**Section 75W Modification Request
Bungarabee Industrial Estate, Huntingwood West Precinct
Metcash Distribution Centre Project Approval MP10_0140 MOD1**

Director-General's Environmental Assessment Report
Section 75W of the *Environmental Planning and Assessment Act 1979*

March 2013

Figure 4: Site plan showing proposed modifications

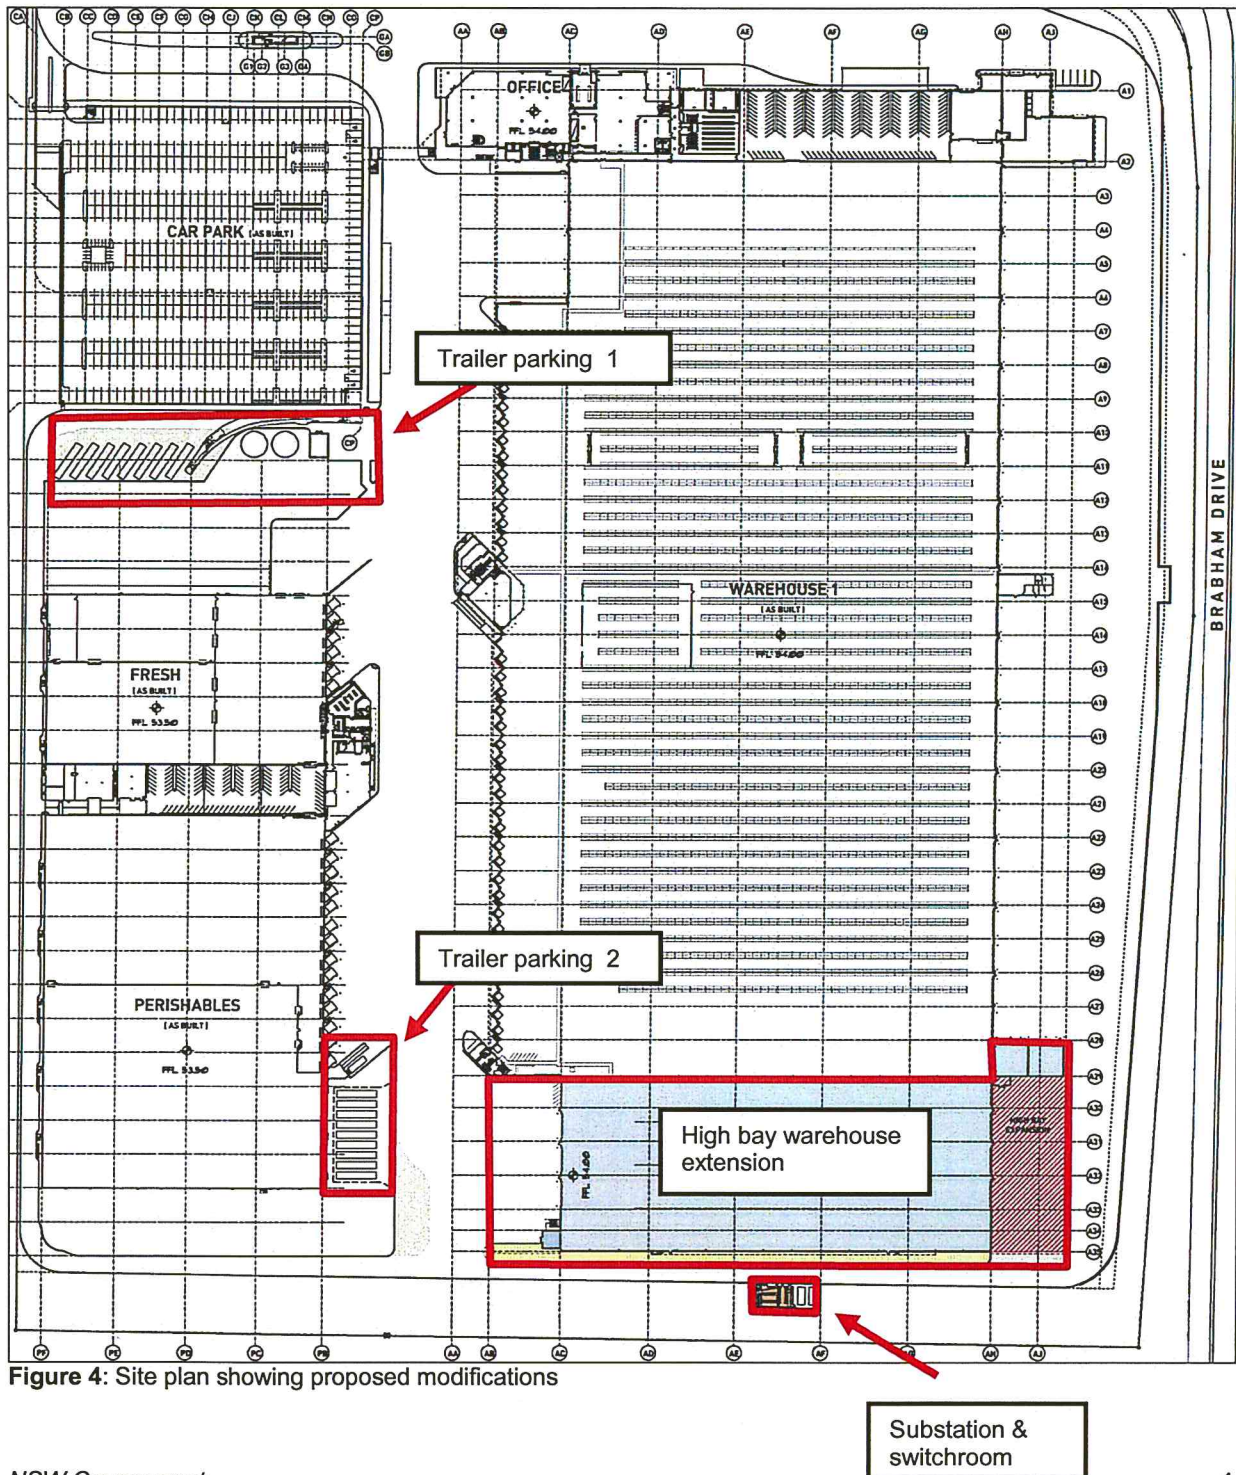
- increase the height and gross floor area of the extension to warehouse 1, including changes to the external facade;
- provide additional trailer parking;
- amend the landscaping;
- alter the approved staging of development; and
- provide a new substation and switchroom.

A substation and switchroom are proposed in the buffer planting zone to the M4 Motorway. They will have a total area of 95m² and be just over 4m in height. See **Figure 4** for their location.

Additional trailer parking is proposed in the location currently approved for the extension to warehouse 3. See **Figure 4** (indicated as 'Trailer parking 1').

This proposed trailer parking will be temporary as after the extension to warehouse 3 is built, it is proposed to be relocated to the eastern side of warehouse 2, see **Figure 4** (indicated as 'Trailer parking 2').

Figure 6: Proposed eastern elevation (southern end of building)

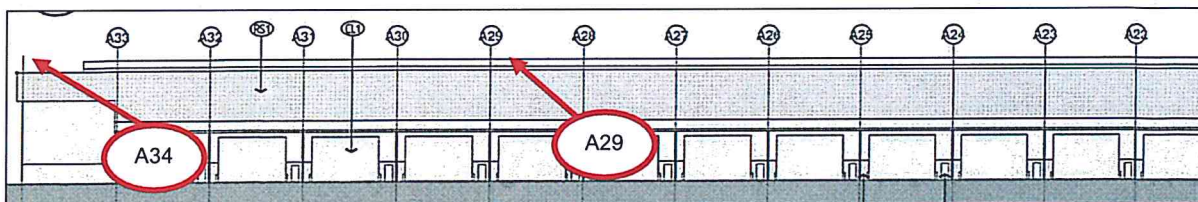
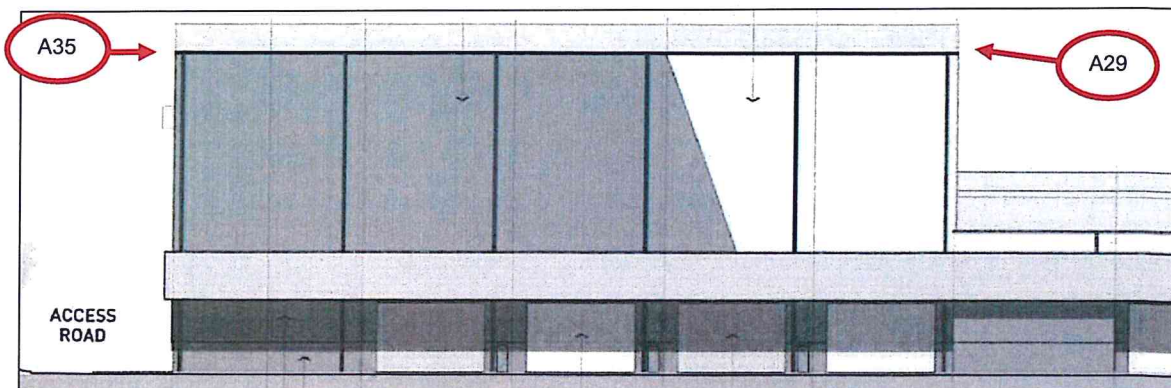
Figures 5 and 6 show the approved and proposed eastern elevations. The extension will commence at bay A29 and continue to bay A35 whereas the approved extension terminated at bay A34.

Figure 9: Proposed southern elevation (showing western awning + further high bay extension)

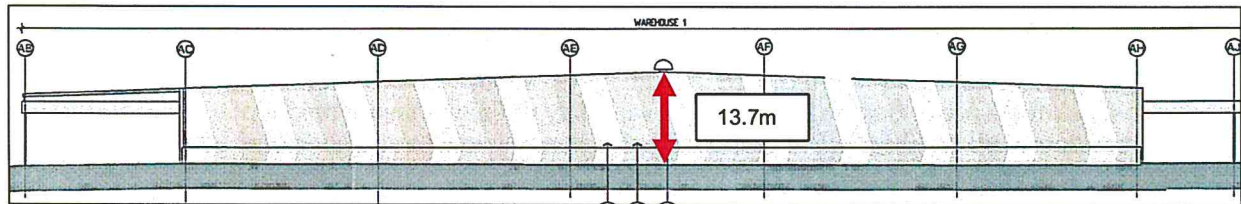
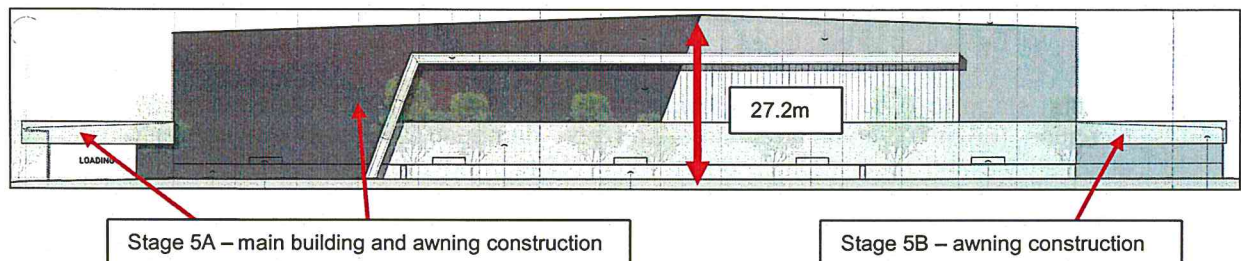
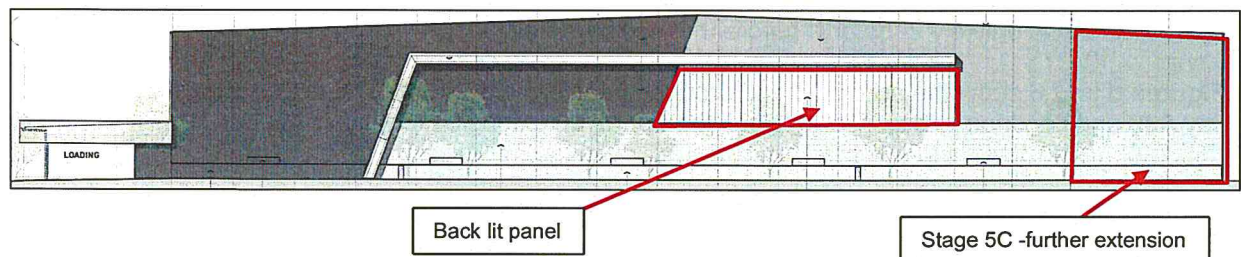
The approved southern elevation is shown in **Figure 7**. **Figures 8 and 9** show the proposed southern elevations before and after the proposed stage 5C high bay extension which will enclose the eastern awning.

The approved facade extension was to be clad in colorbond sheeting and have a chevron pattern (see **Figure 7**). Colours included three pale tan tones. No structural features were proposed to break up the bulk.

The external appearance of the proposed warehouse extension will be a mixture of materials and shades with structural features to break up the bulk. See **Figure 9**.

A back lit panel of polycarbonate sheeting (see **Figure 9**) is proposed. It will be subtly lit to show up proposed future signage at night. Regardless of any proposed signage, the back lit panel will provide interest to the facade and assist in breaking up the bulk of the extension.

Council has stated that all building materials on the southern elevation must be non reflective materials to ensure no impacts or distractions to traffic. This can form an additional condition to any modification approval.

Figure 10: Proposed staging plan

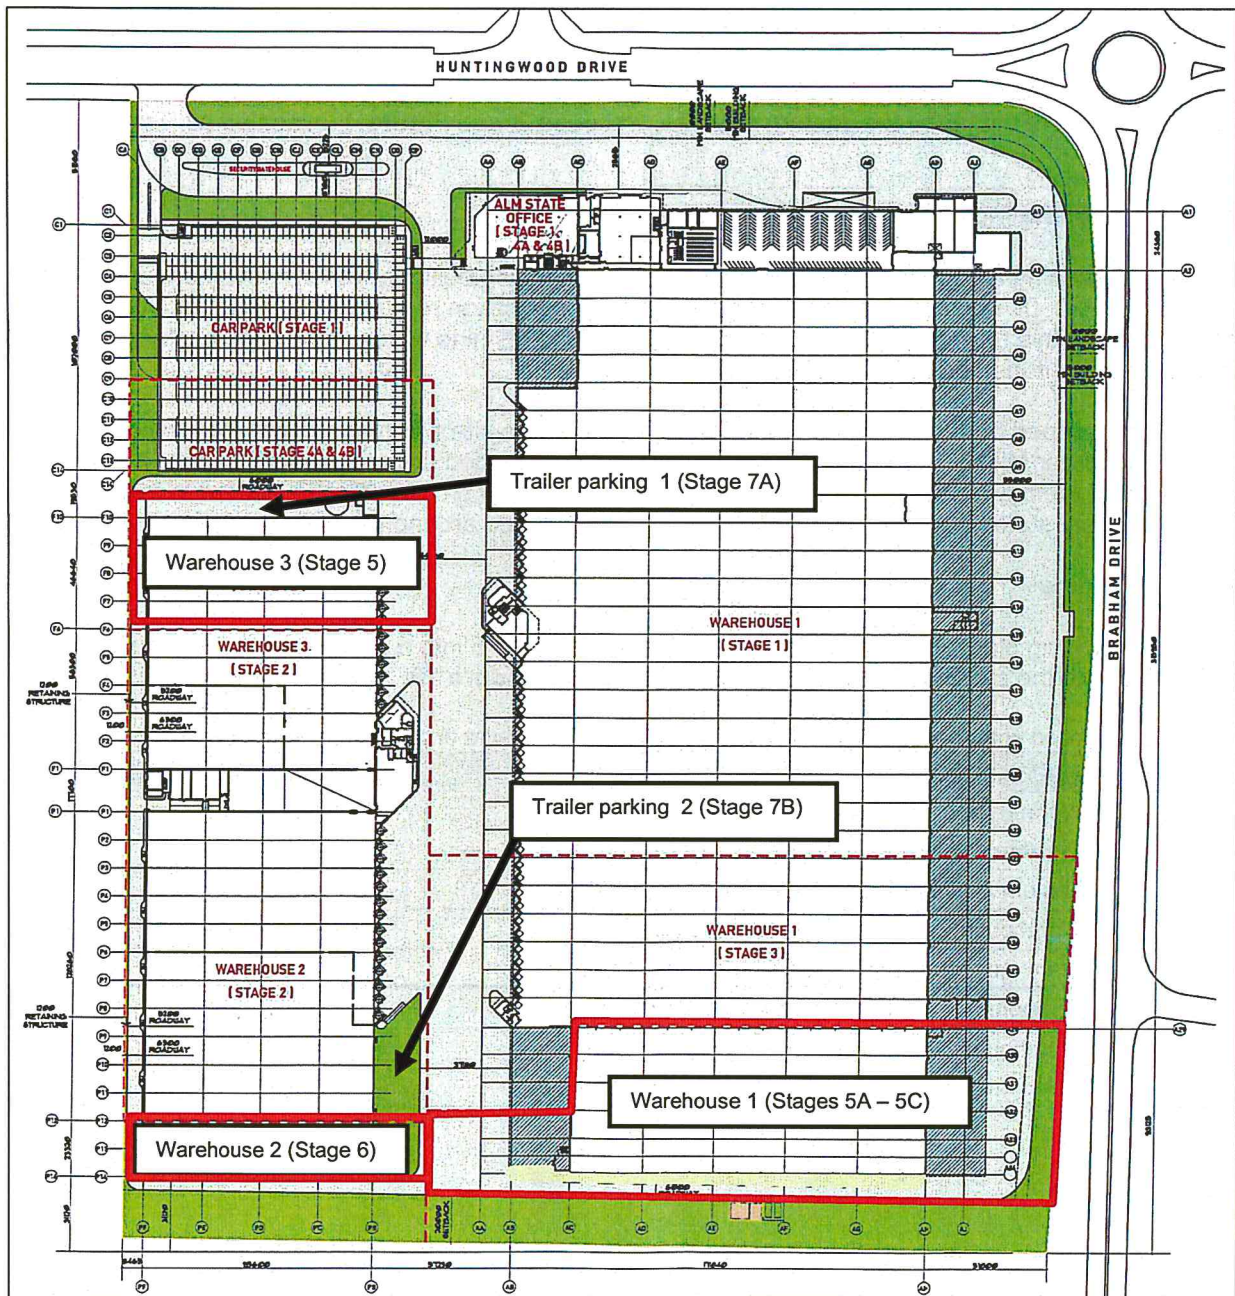
Grass landscaping along the southern elevation of the Metcash building was approved under project approval MP10_0140 (see **Figure 10**). As part of the modification request, tree, shrub and grass planting along this elevation are now proposed which includes nine water gums spaced along the frontage with shrubs and native grasses located in between.

A 20m landscaped buffer area which extends along the entire site's frontage to the M4 Motorway (approved under MP10_0140, see **Figure 10**) remains unchanged under this modification, with the exception of the new substation and switchroom which are now proposed to be located in this area. The proponent states that planting in this area will be relocated around the new structures.

A revised staging plan which breaks down the approved stage 5 into a further five stages has been submitted with the modification, as outlined in **Table 2** and **Figure 10**.

- It is recommended that a condition of approval be imposed to require the proponent to provide additional planting within the landscaped buffer area between the M4 Motorway and the building.

The submitted landscape plan indicates only 9 trees with a mature height of 9m will be planted. This is not considered sufficient for an area approximately 200m in length. It is considered a minimum of 25 trees shall be planted to a mature height of between 15-20m.

The plantings proposed along the building frontage to the proposed high bay warehouse extension will include tree, shrub and grasses. Nine water gums will be spaced along the frontage with shrubs and native grasses in between the trees. One of council's concerns was the lack of planting in this location to screen the extension. It has been clarified with council that the new plantings along the building frontage are not for screening purposes but to break up and soften the facade. Screening will continue to be provided by the 20m wide landscaped buffer to the M4 Motorway along with the landscape buffer external to the site, in between the site boundary and the M4 Motorway. Additional trees along the building facade would contribute little to screening when there is substantial buffer planting within and immediately outside the subject site.

The department does not object to the modifications to the landscaping. The proposed high bay warehouse extension will be partially screened by the existing landscaped buffer adjacent to the M4 Motorway. Further, the proposed additional planting directly along the building frontage will assist in breaking up the bulk of that frontage.
